## RECALL NOTICE

3730 Anchorage Connector

September 30, 2010

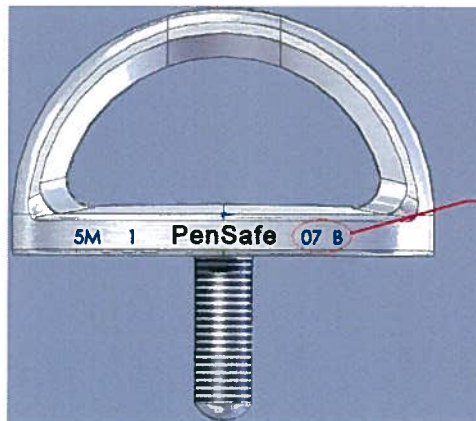
We have identified an issue with a batch of 3730 Anchorage Connectors manufactured in the latter part of 2007 and distributed by PenSafe Inc. from June 2008 through June 2009. We have examined a part as part of a root cause analysis which exhibits a heat treatment deficiency. The result is a potential embrittlement on anchorage connectors with the 07 B year and heat code. This embrittlement may cause the threads on the stem to fracture prematurely from the stress created by the torque of the nut during installation. Note that this may not be evident at the time of installation and the fracture may develop over time.

In order to find and remove the defective parts from use, PenSafe is issuing this recall for all 3730 anchorage connectors with manufacturing code "07 B". The diagram below identifies the location of this manufacturing code for positive identification of the suspect product. It will appear to the right of the PenSafe name.

In response to this issue PenSafe has implemented a corrective action change in the approach to the proof loading of the 3730. The threaded portion is now mounted in a plate and subjected to proof load in conjunction with the load on the ring. Should you have additional questions or concerns with regard to this issue, please contact PenSafe directly at 1-866-212-2211, and ask for Bob Claus at extension 233, or Keith Smith at extension 243.
